REMARKS

Amendments to the Drawings:

FIG 3

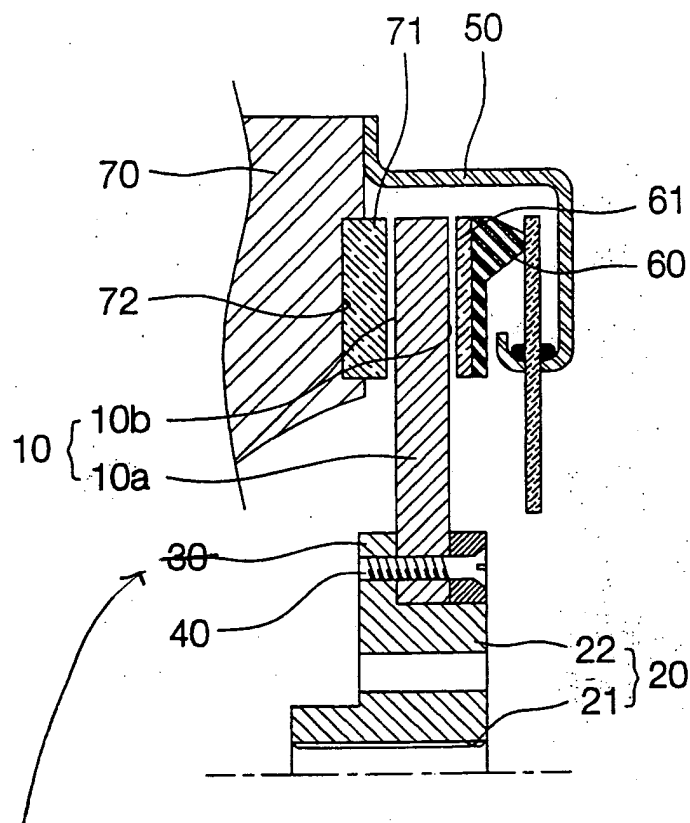
In Figure 3, reference numeral "30" has been deleted.

delete reference numeral "30"
